DEFENDANT'S
EXHIBIT
D-63

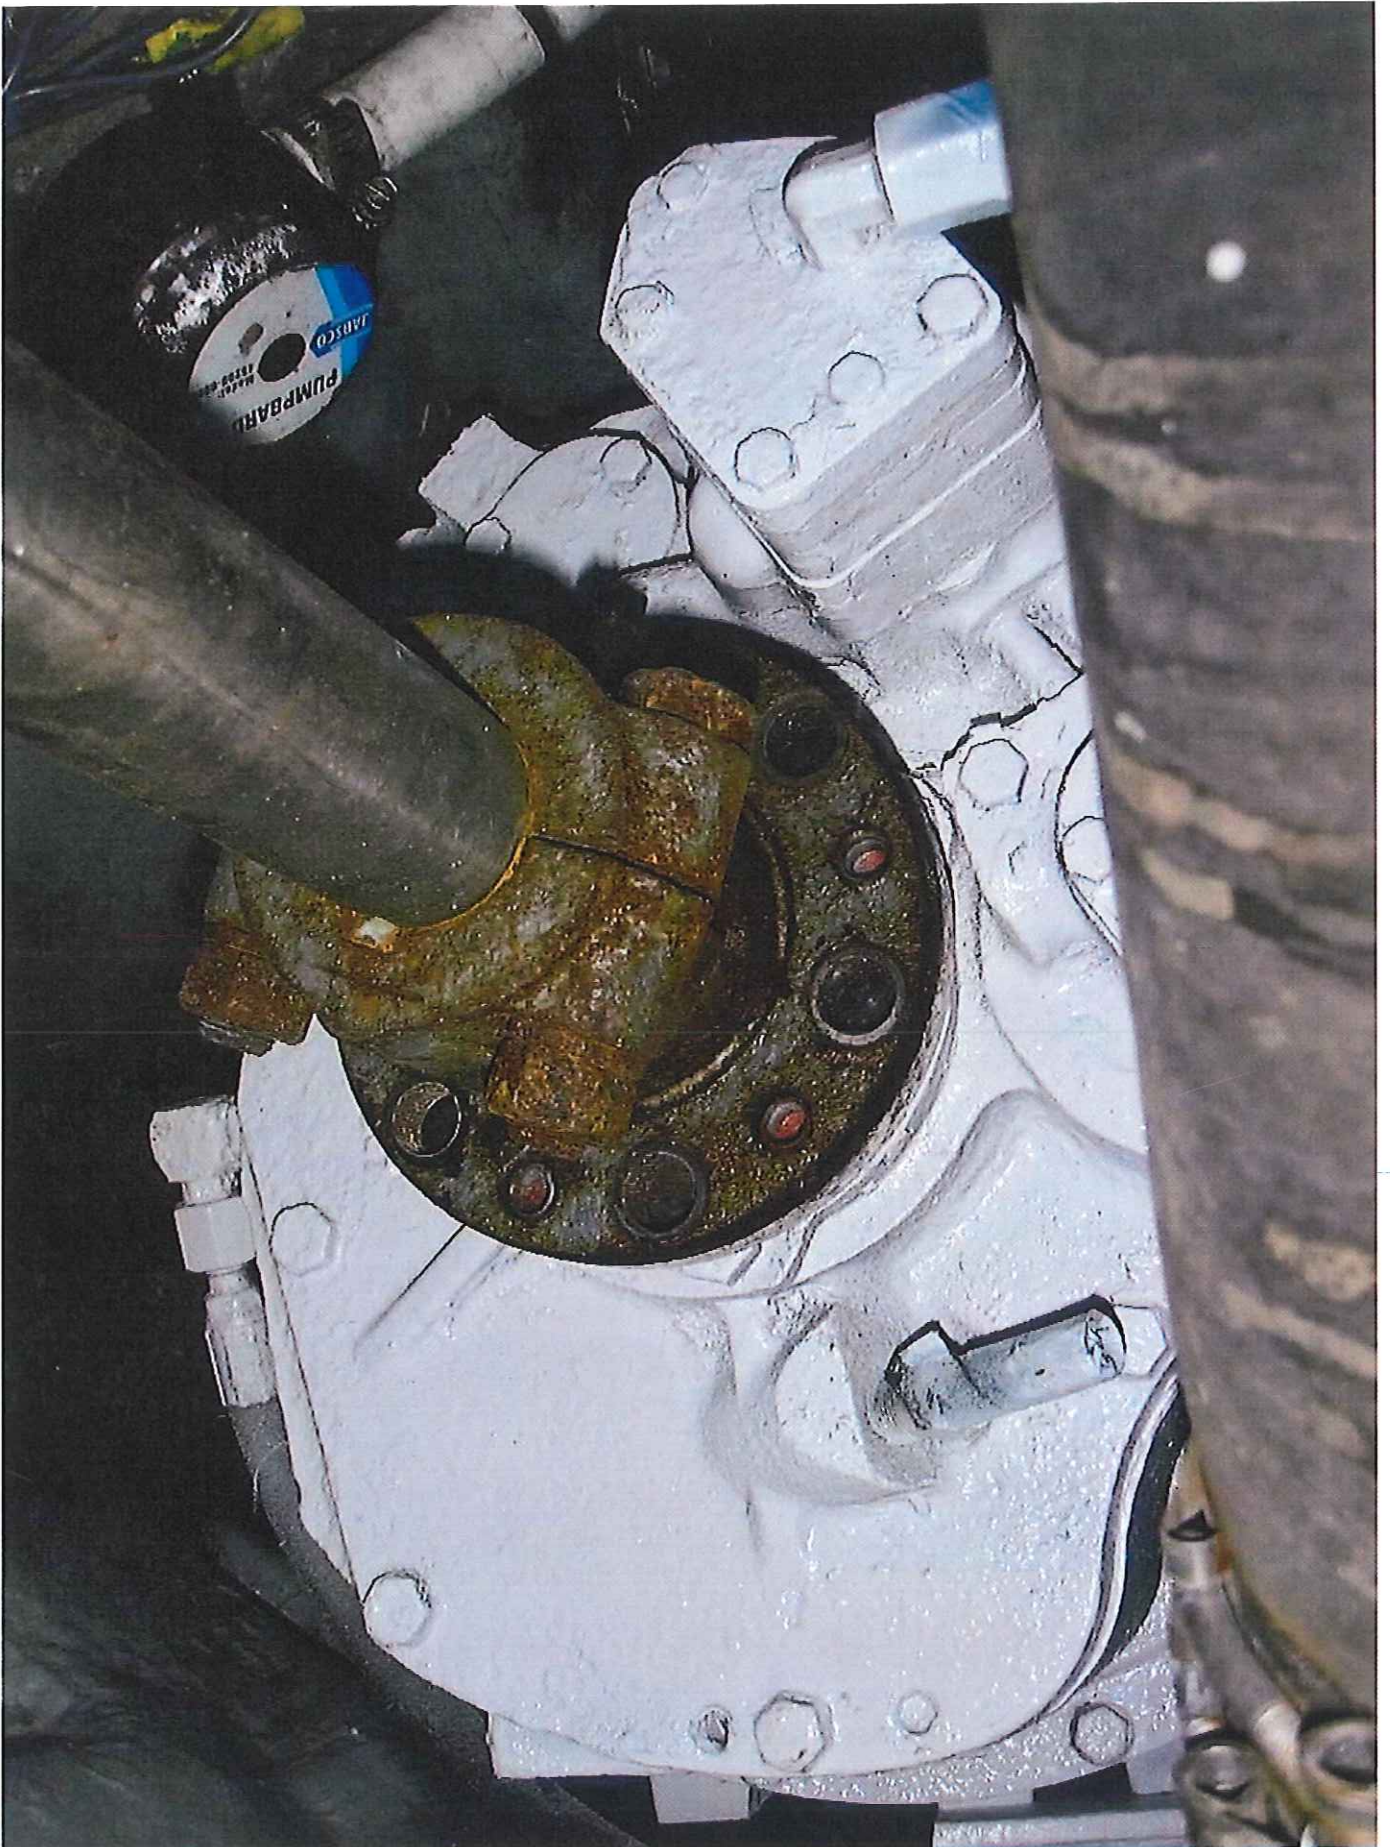
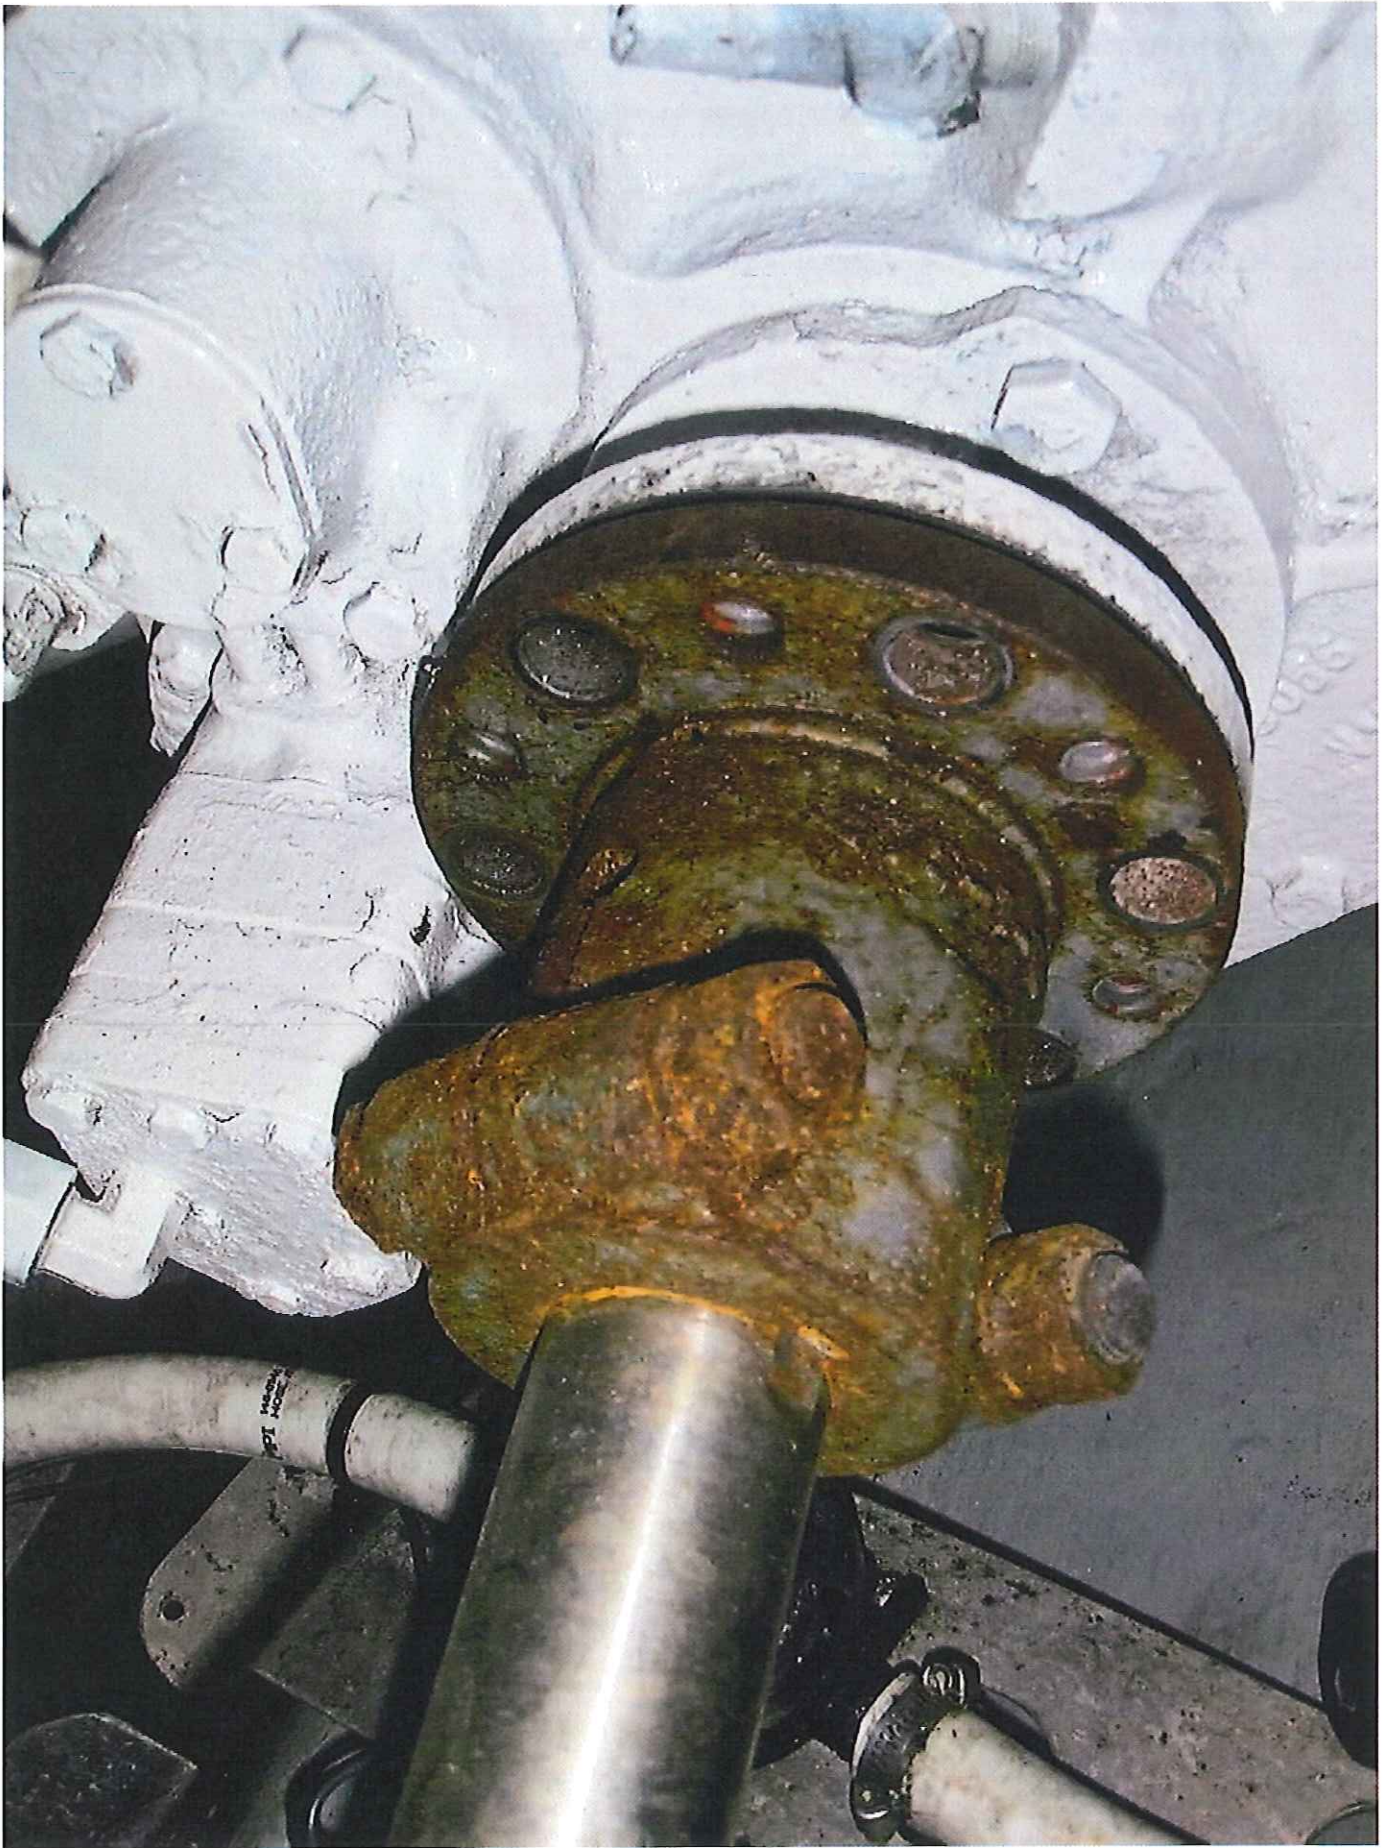
**Loop in the crossover
fuel line that should be
eliminated to prevent a
"water collection" area**

**Shut off valve
should be added**

PORT tank

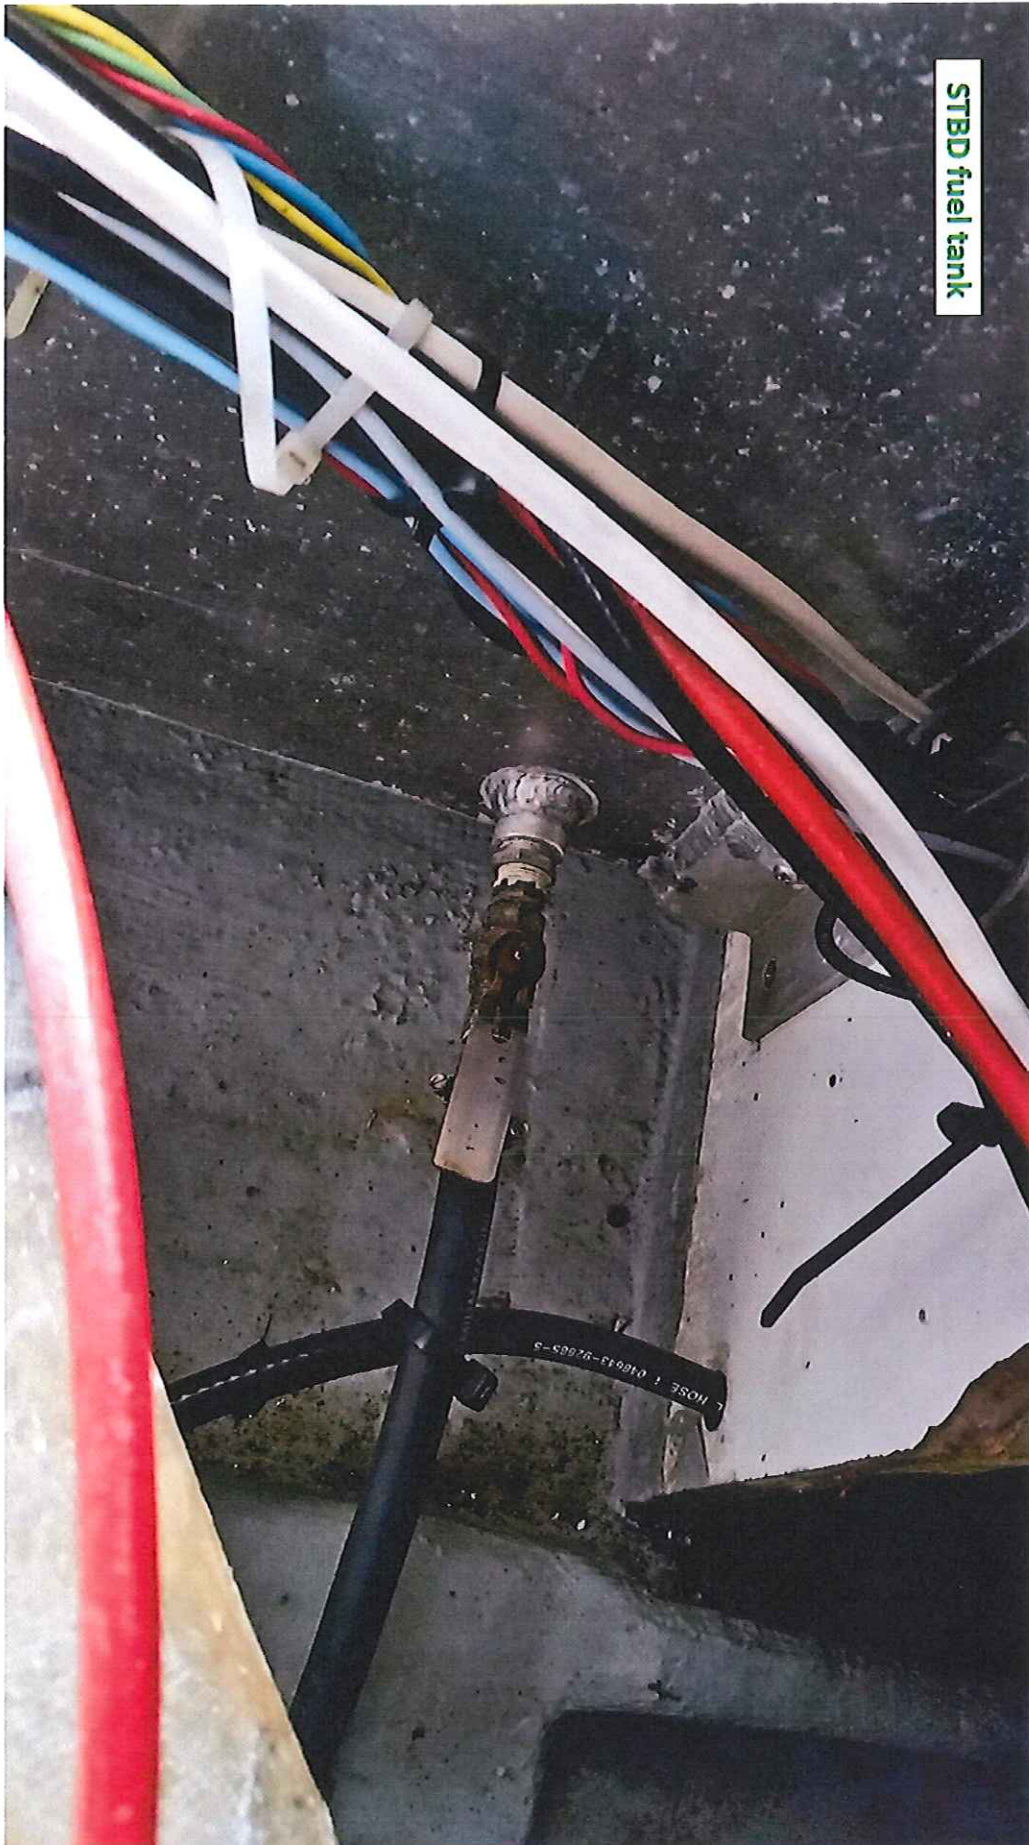
NO shut-off valve on the PORT fuel tank
(see ADAC H33.14.2)

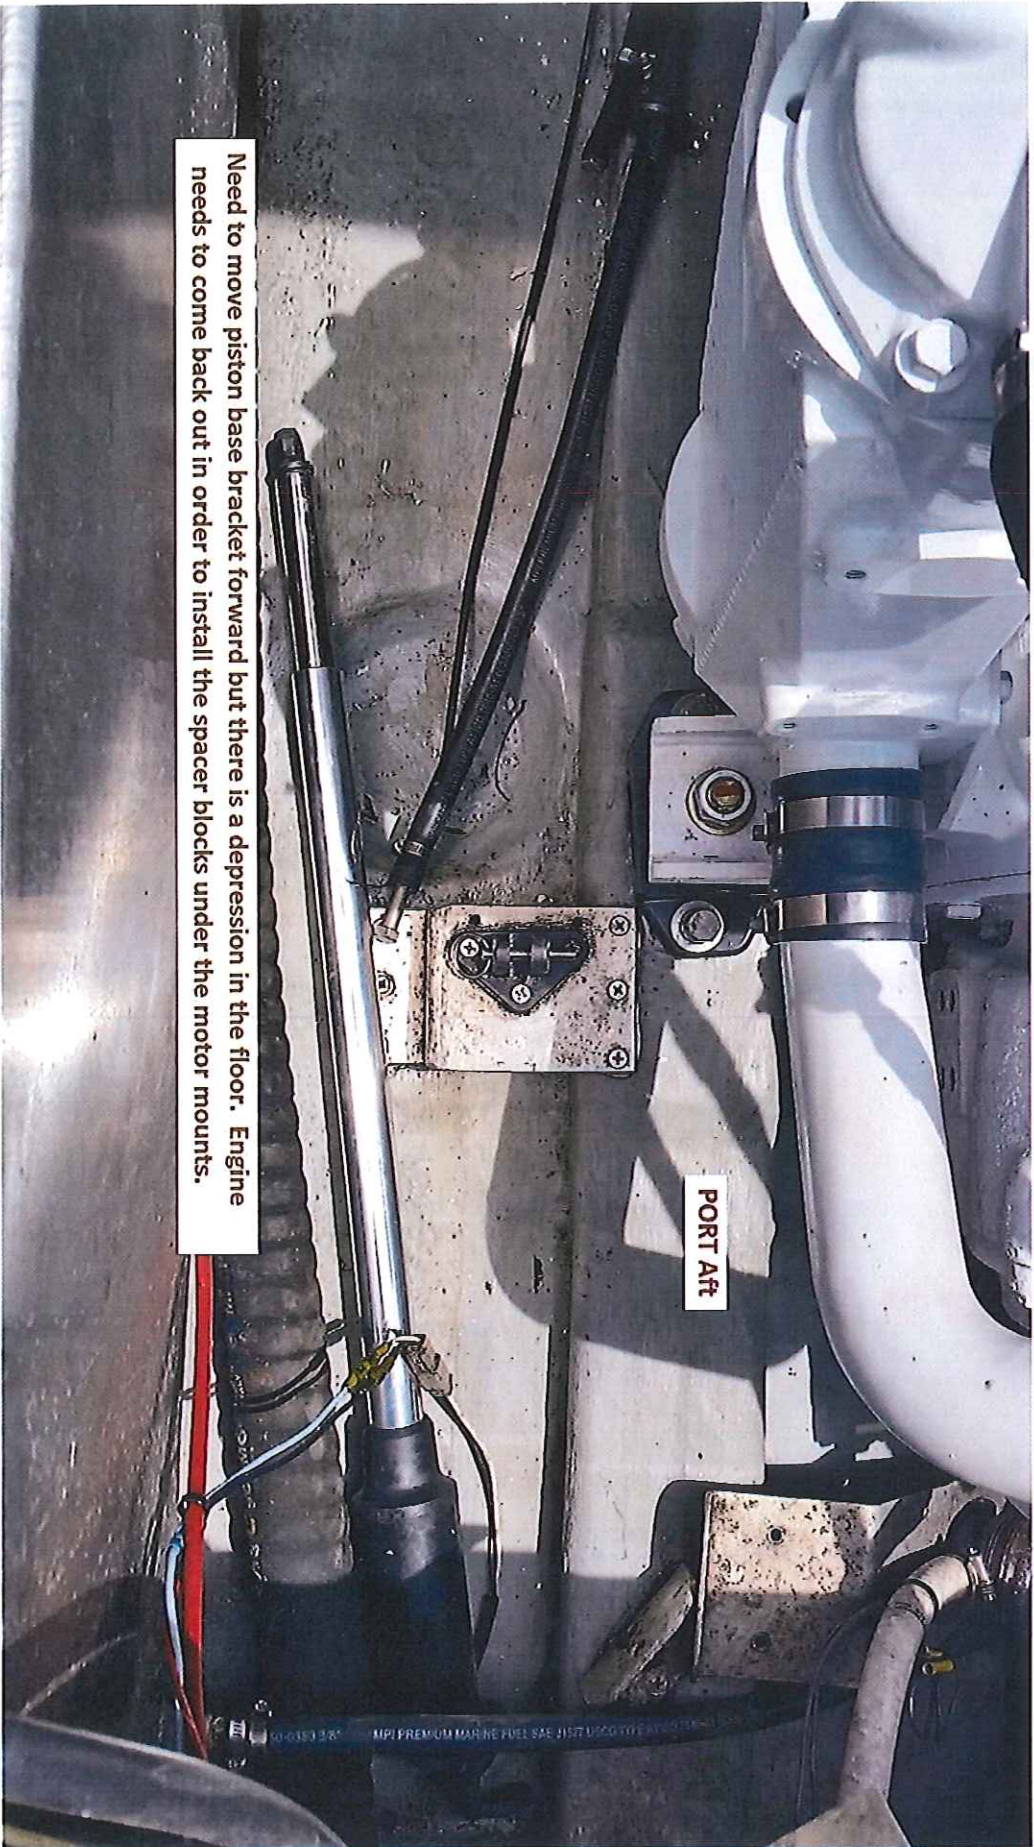
Need to move piston base bracket forward but there is a depression in the floor. Engine needs to come back out in order to install the spacer blocks under the motor mounts.
